# **BSA SUBMISSION NOTICE**

BSA Calendar #: 2019-94-AElectronic Submission: ☒ Email ☐ CD

Address: 36 West 66th Street, a.k.a 50 West 66th Street, New York, New YorkApplicant Name Stuart A. Klein, Esq./LandmarkWest!

### **SUPPLEMENTAL STATEMENT OF FACTS**

# EXHIBIT DRAWING NO: 17

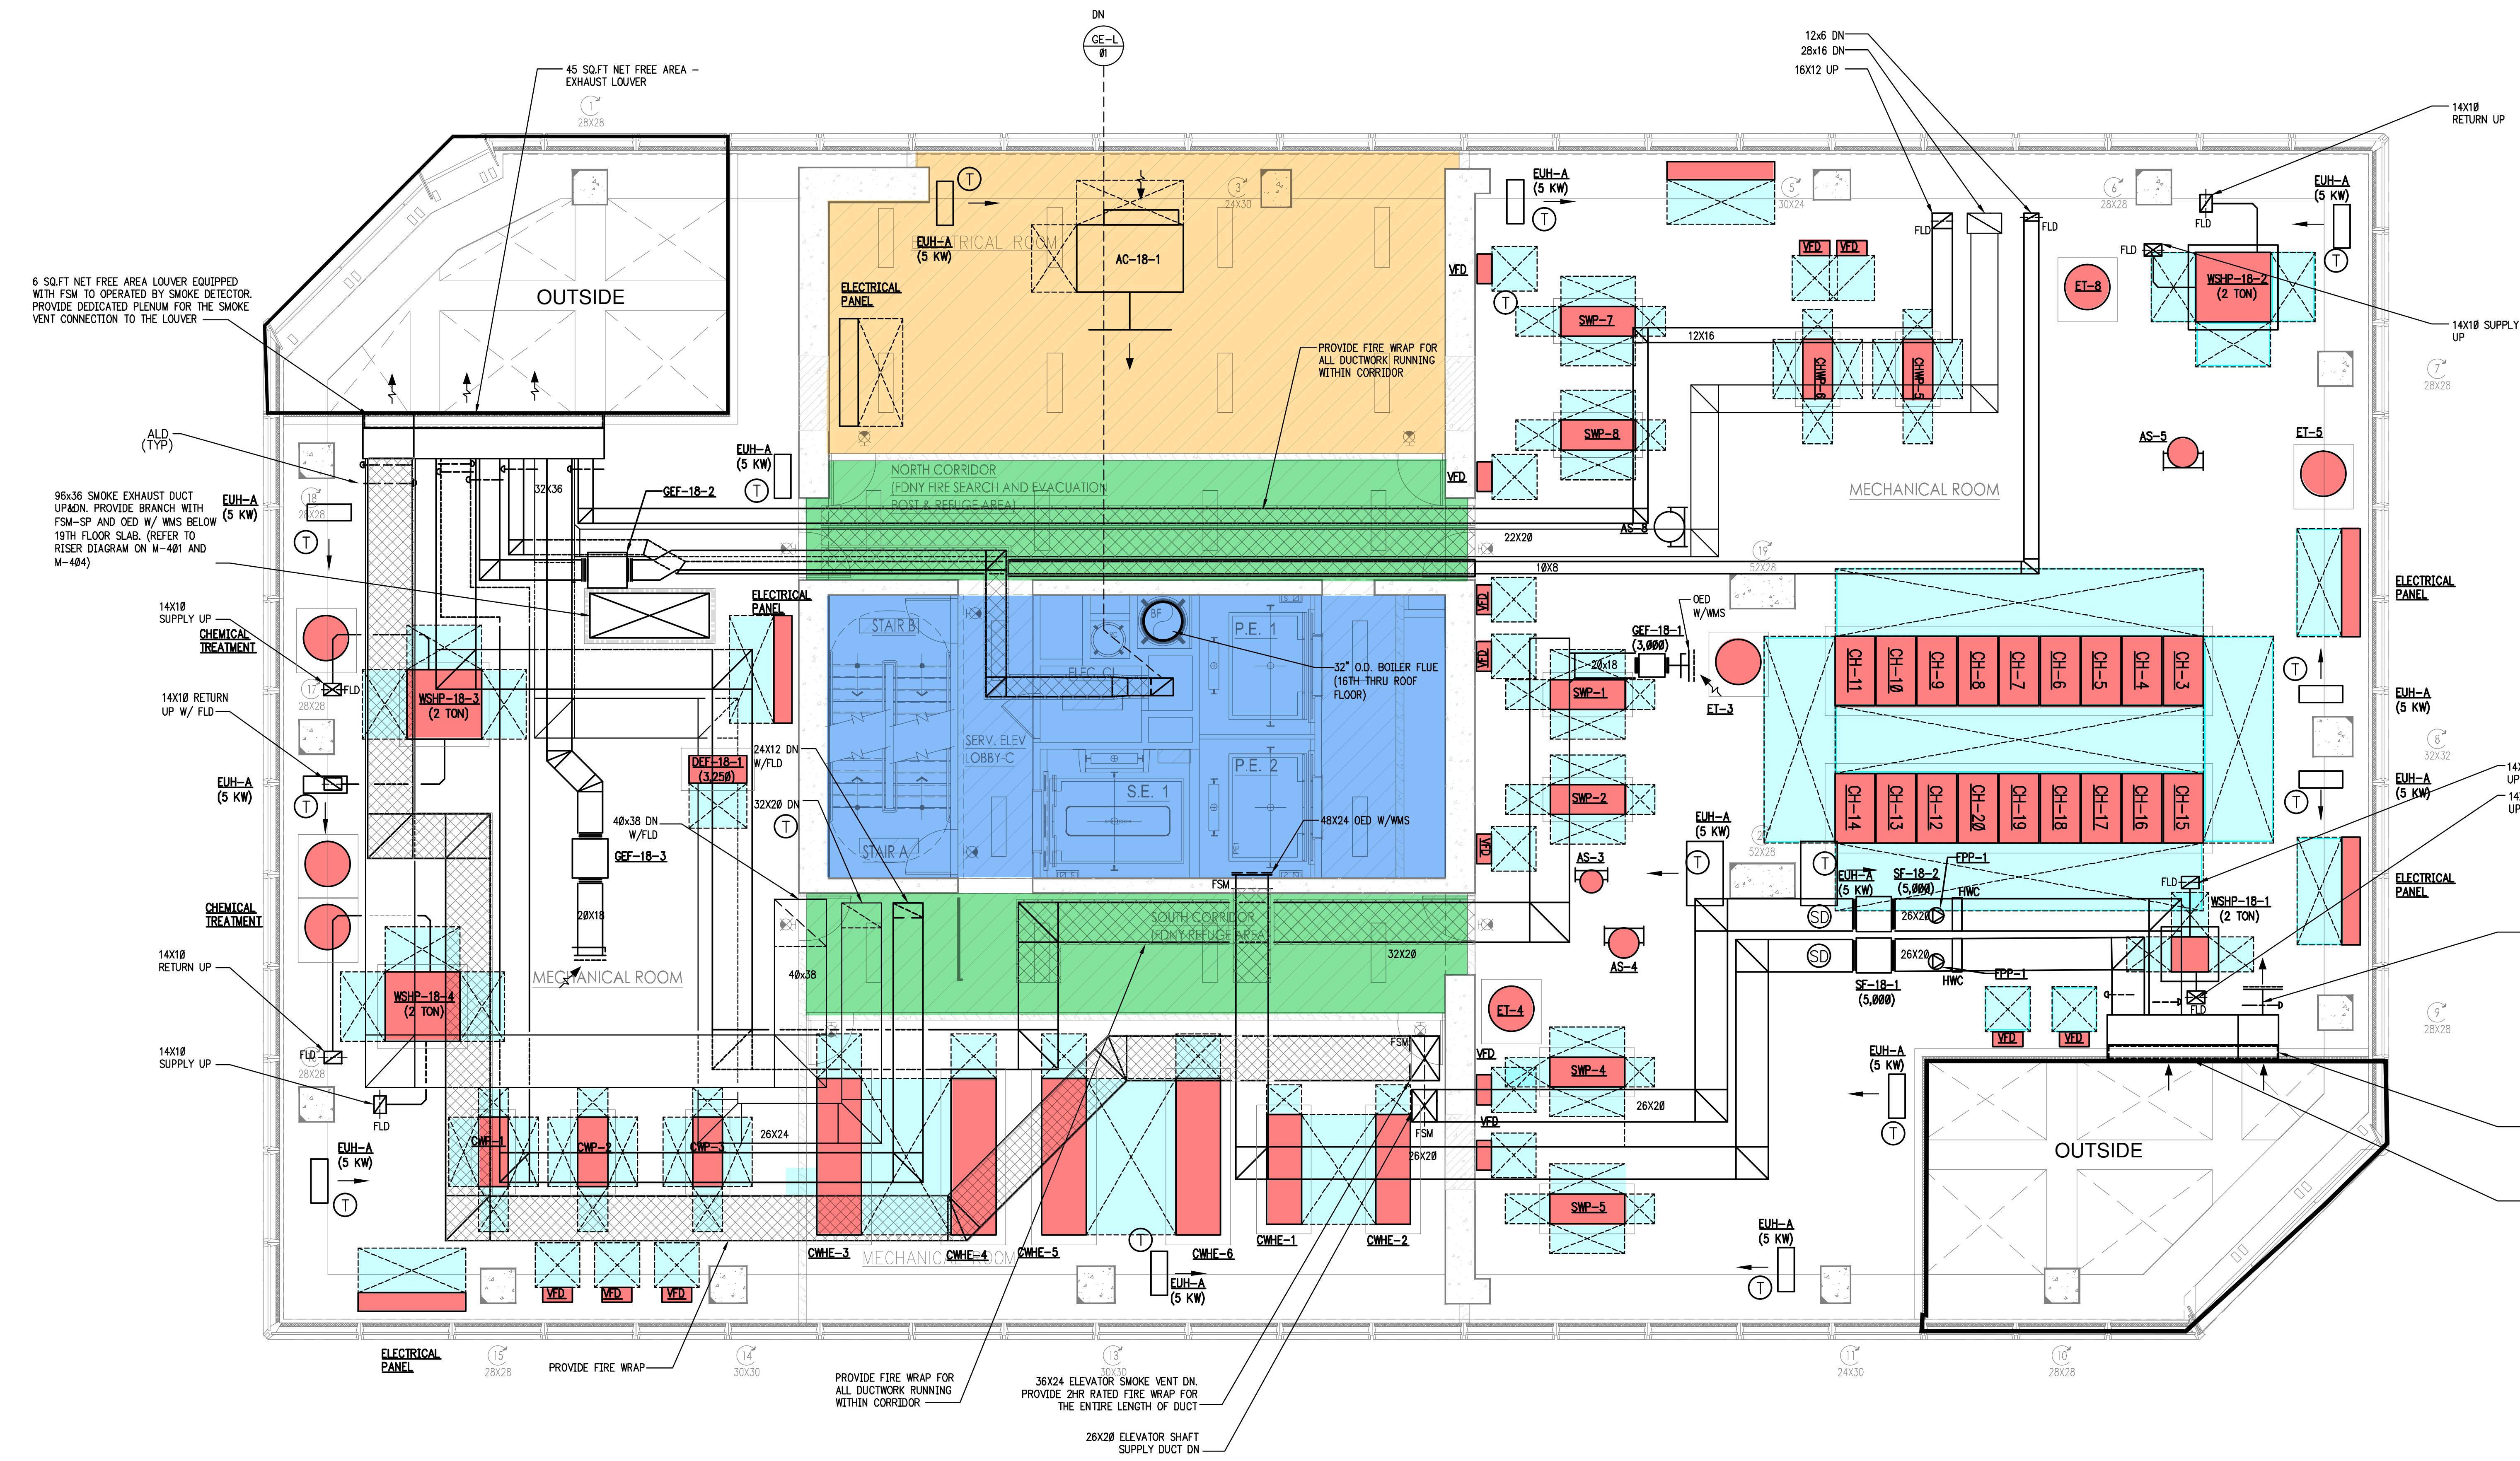
### 17TH FLOOR AREA CALCULATIONS

MECHANICAL EQUIPMENT	412.2 SF
REQUIRED CLEARANCES	1,308 SF
FDNY ACCESS	563 SF
ELECTRICAL	372 SF
CIRCULATION	1,171 SF
WHITE SPACE	6,418.8 SF
<b>TOTAL FLOOR AREA</b>	<b>10,216 SF</b>

### TOTAL ALLOWABLE DEDUCTIONS MECHANICAL/ ELECTRICAL

412.2 + 1,308 + 372 = 2,092.2 SF

PERCENTAGE OF FLOOR AREA

2,092.2 / 10,216 = 20%

# EXHIBIT DRAWING NO: 18

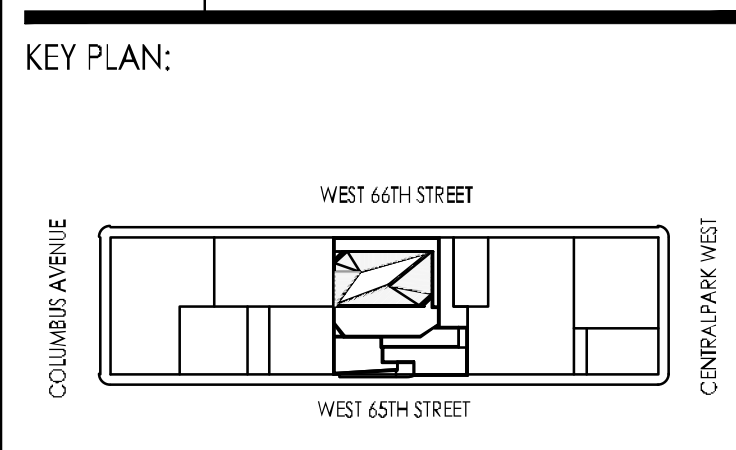
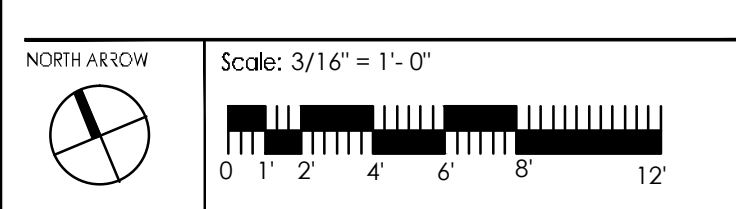
In order to illustrate this and the amount of equipment, the “footprint” and spatial organization, I color-coded all of the differing components of the MEP system. The attached color-coded Exhibit Drawing Nos. 15, 17, 18, and 19 of each major mechanical floor identifies the area of the equipment, the access/service space required for each, as well as other uses on the floor and the unassigned or “white space.” **As designed, the equipment and service area requirements are approximately** as follows (see attached Existing Conditions Drawings for respective calculations):

- 15th floor..... 18 %
- 17th floor..... 20 %
- 18th floor..... 27 %
- 19th floor..... 28 %

CONSOLIDATED MECHANICAL EQUIPMENT LAYOUT ONLY  
17TH FLOOR  
11-06-2019

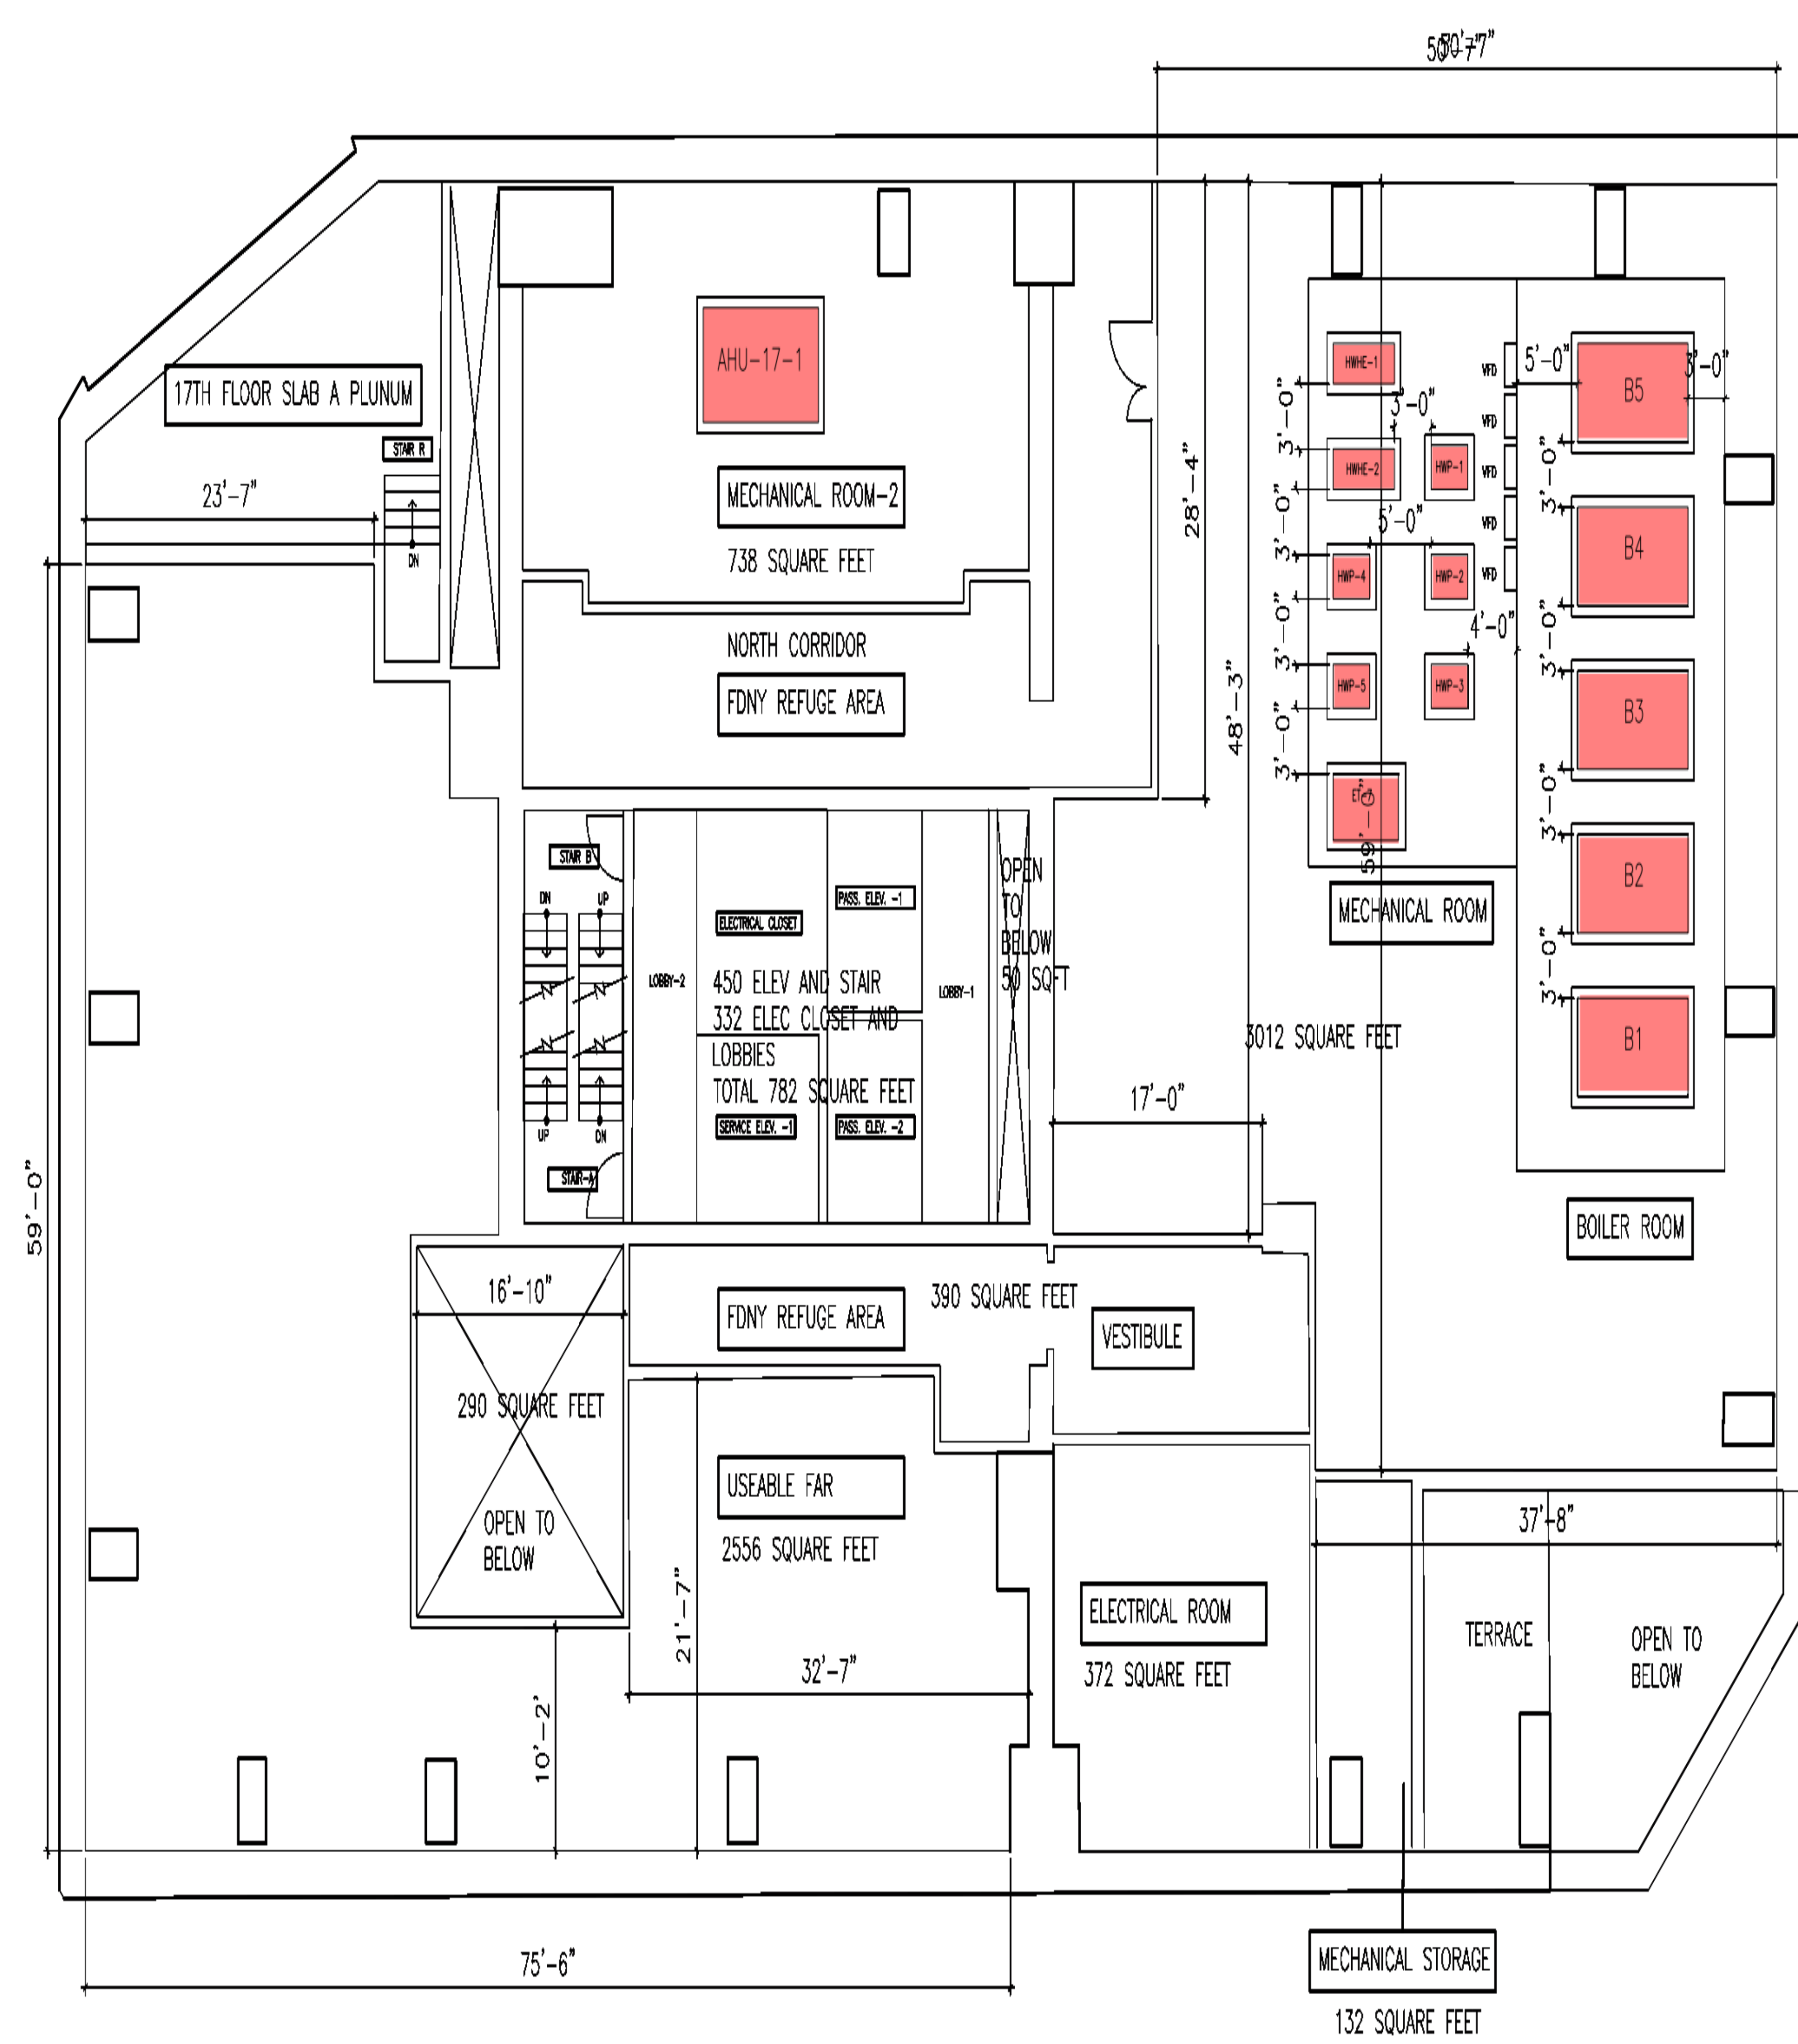
be a more efficient use of the floor area. The 17th floor zoning calculations claim complete use of the spaces for MEP use. I laid out the equipment using a more typical approach of sharing access aisles and service space. As shown on the attached Comparison Diagrams, expressly 17.1 17.2, two of the four major mechanical spaces could be eliminated if a more aggressive design concept and philosophy was followed. The existing design shows overall mechanical rooms of 8,481 sq. ft. of space; the revised design would be 4,122 sq. ft. of overall mechanical space.

Since the space is not all used for MEP and is partly shared with the FDNY, the mechanical deduction for the entire floor, 10,216 sq. ft. would now become 4,122 sq. ft.; a reduction of sixty percent (60%). If this percentage were applied across the four main mechanical floors, the mechanical deduction would be reduced from 51,851 sq. ft. to 24,740 sq. ft.
